# Permit Revision Submittal Requirements and Application

21-101232 REV 01 RS

Project Name and Address  
NEELY/PRICE RESIDENCE  
ADDITIONS AND ALTERATIONS  
8333 SE MADISON ST  
PORTLAND, OR 97216

3 DOOR TYPES  
A4 SCALE: 1/4" = 1'-0"

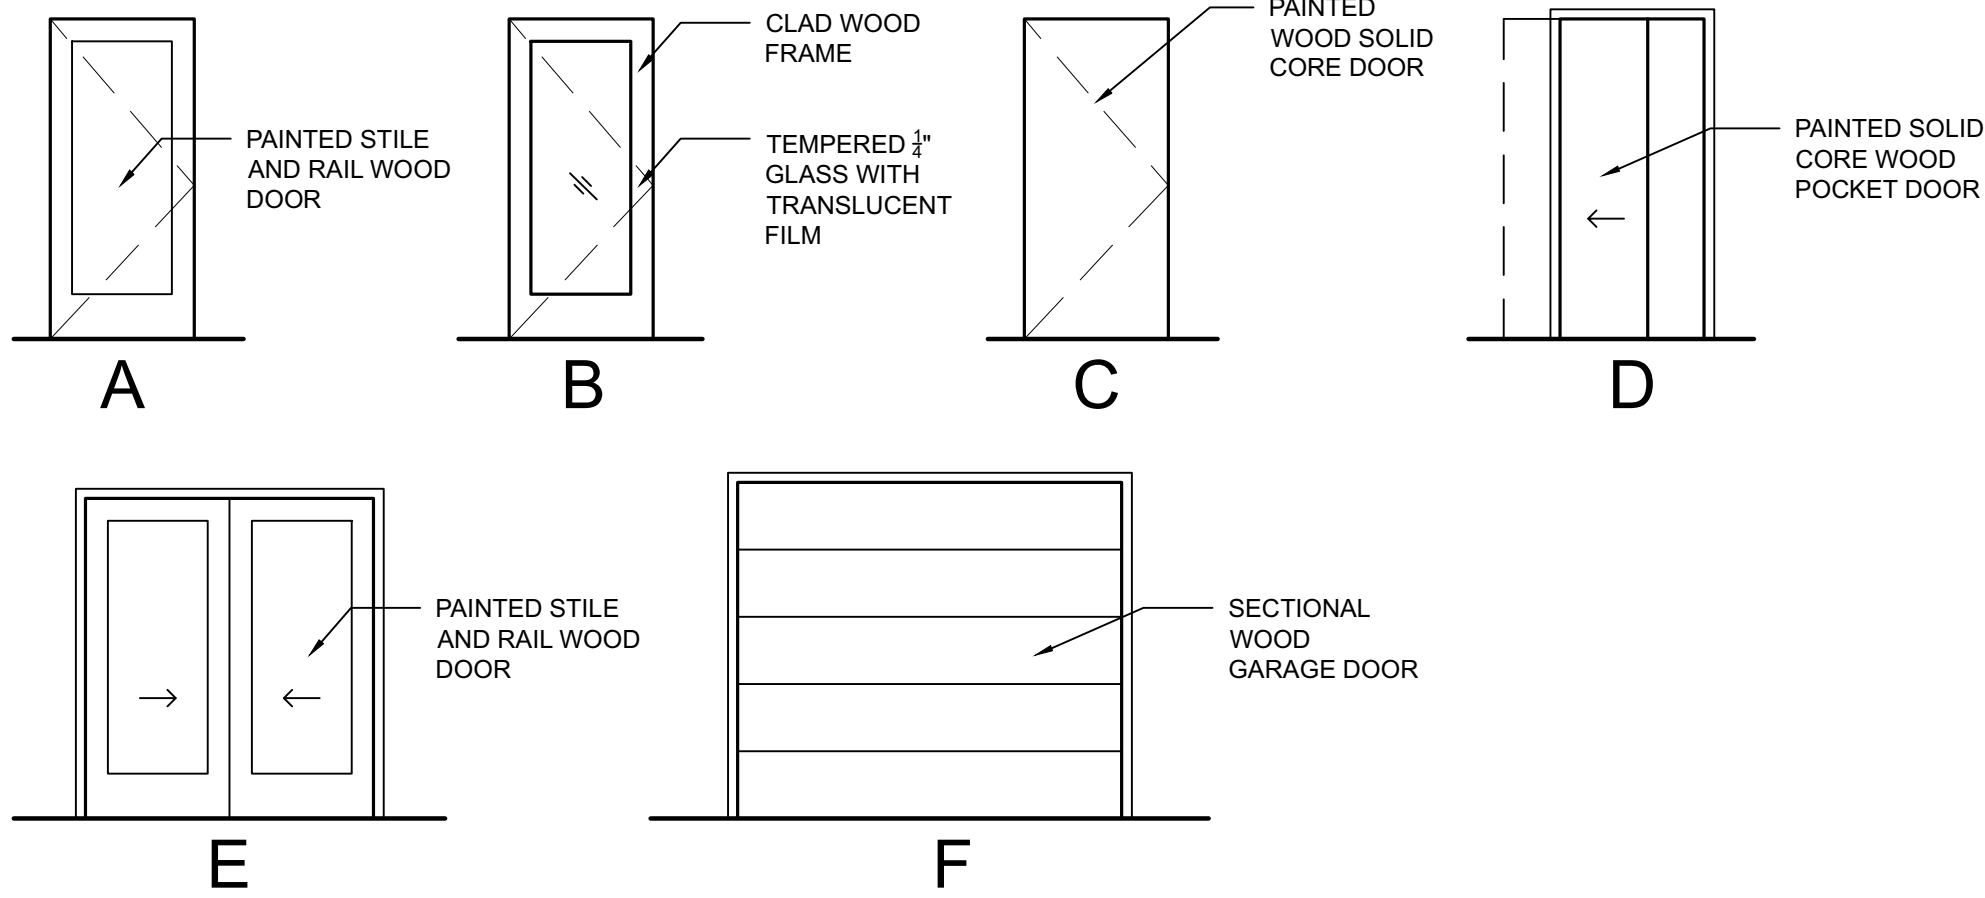
The changes include revising the rating of doors types 3 and 5 from 1 hour to 20 minutes. Code requires 20 minutes not 1 hour for these. Also revises wall types B and C, 1/2" gypsum board is code in lieu of 5/8"
